07/411,576 09/22/89 MAGLICA

Advisory ActionApplication No.
07/411,576Applicant(s)
MaglicaExaminer
M. H. TungGroup Art Unit
2901**THE PERIOD FOR RESPONSE: [check only a) or b)]**

The shape of the flashlight head has not been amended for consistency with the parent application. The benefit of the filing date of parent case 06/648032 is denied. Also, the threaded portion still appears proportionally wider in the

FIG. 1.

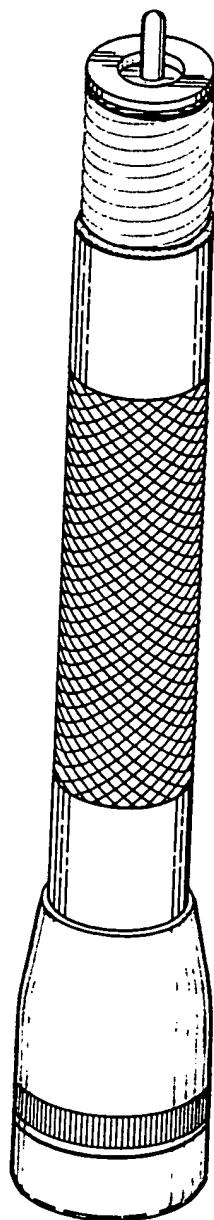
1. The drawing submitted 02/27/96 is objected to for the following reasons:
 - a) Upon further consideration of the drawings, the end shown in Fig.3 shows one less concentric circle than the original Fig.3. Also, the middle concentric circles are spaced closer together than in the original Fig.3. Note A on the attached photocopy.
 - b) The threaded portion in Fig.2 is drawn in the opposite direction from Fig.1. Consistency is required. Note B.
 - c) The Fig.4 end view shows one less concentric circle than in the original Fig.4. Note C.

Correction is required. 35 U.S.C. § 112 paragraph 1, 37 C.F.R. § 1.152.
